SOUTHERN INDUSTRIAL PARK SUBDIVISION,
LOT A, RESUBDIVISION OF LOTS 7 & 8

APPLICATION NUMBER 4 DATE September 2, 2010

APPLICANT Southern Industrial Park Subdivision, Lot A, Re-subdivision
of Lots 7 & 8

SITE PLAN

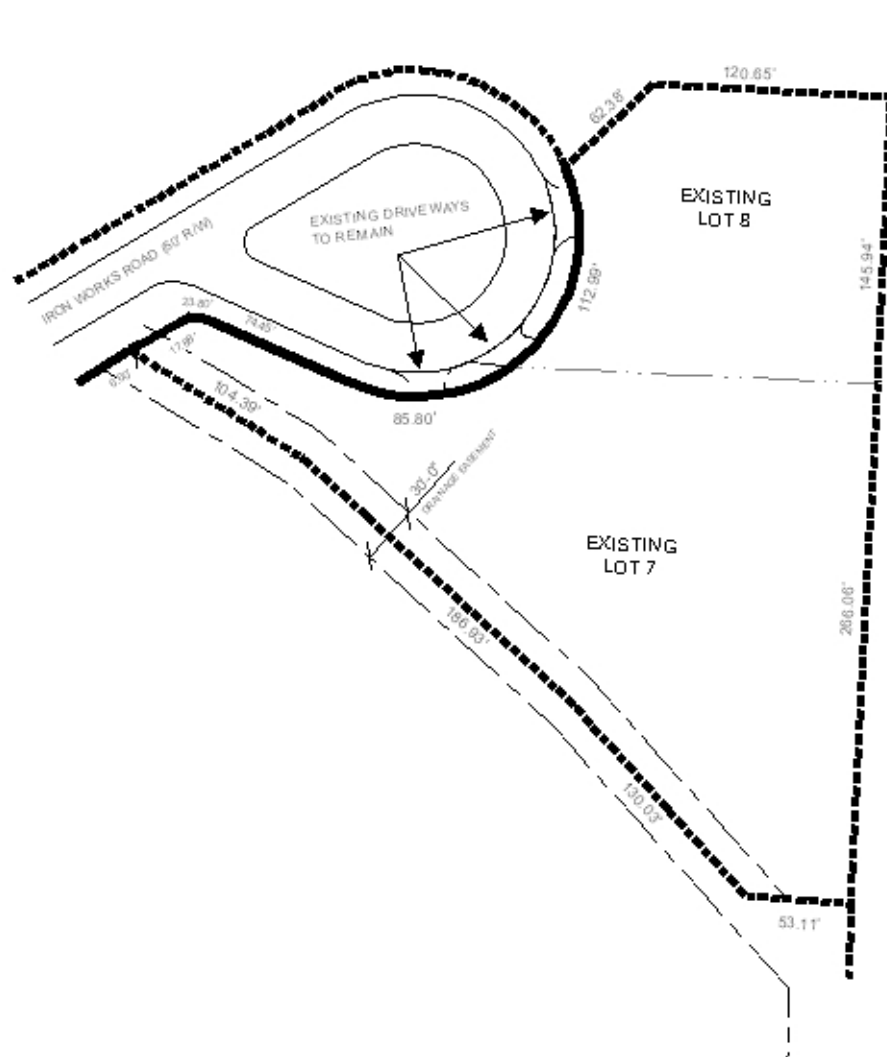
Engineering Comments: Need to increase width of existing easement to include an area at least 20' from the top of the existing ditch, or as otherwise approved by the City Engineer, to allow for adequate access to and maintenance of the ditch. On the plat, label Ironworks Road as a private road. Must comply with all storm water and flood control ordinances. Due to the undersized drainage system and history of flooding during rain events at the downstream location at Larue Steiner, detention (100 year storm with 10 year release) will be required for any increase in impervious area. Any work performed in the right of way (including easements) will require a right of way permit, in addition to any required land disturbance permits. Drainage from any new dumpster pads cannot discharge to storm sewer; must have connection to sanitary sewer.

Although Ironworks Road is a private street, access management is still a concern; therefore, a note should be placed on the Final Plat stating that the subdivision is limited to the existing curb-cuts along Ironworks Road with the size, location, and design of any additional curb-cuts to be approved by Traffic Engineering and conform to AASHTO standards.

The lot is not labeled on the plat with its size in square feet, and should be so-labeled on the Final Plat, or a table should be provided furnishing the same information.

It should be noted that the preliminary plat does not illustrate the 25-foot minimum building setback line; thus, the plat should be revised to show the 25-foot setback line along Ironworks Road.

This application was heldover at the August 5th meeting at the applicant's request, to allow discussions with Engineering regarding the necessity of additional easement area along the South property line for the drainage ditch.

- 1) *placement of a note on the Final Plat stating that the subdivision is limited to the existing curb-cuts along Ironworks Road with the size, location, and design of any additional curb-cuts to be approved by Traffic Engineering and conform to AASHTO standards;*

- 2) *depiction of the 25-foot minimum building setback line along Ironworks Road;*
- 3) *labeling of the lot with its size in square feet, or the provision of a table on the plat furnishing the same information;*

- 4) *compliance with Engineering comments: (Need to increase width of existing easement to include an area at least 20' from the top of the existing ditch, or as otherwise approved by the City Engineer, to allow for adequate access to and maintenance of the ditch. On the plat, label Ironworks Road as a private road. Must comply with all storm water and flood control ordinances. Due to the undersized drainage system and history of flooding*

during rain events at the downstream location at Larue Steiner, detention (100 year storm with 10 year release) will be required for any increase in impervious area. Any work performed in the right of way (including easements) will require a right of way permit, in addition to any required land disturbance permits. Drainage from any new dumpster pads cannot discharge to storm sewer; must have connection to sanitary sewer.);
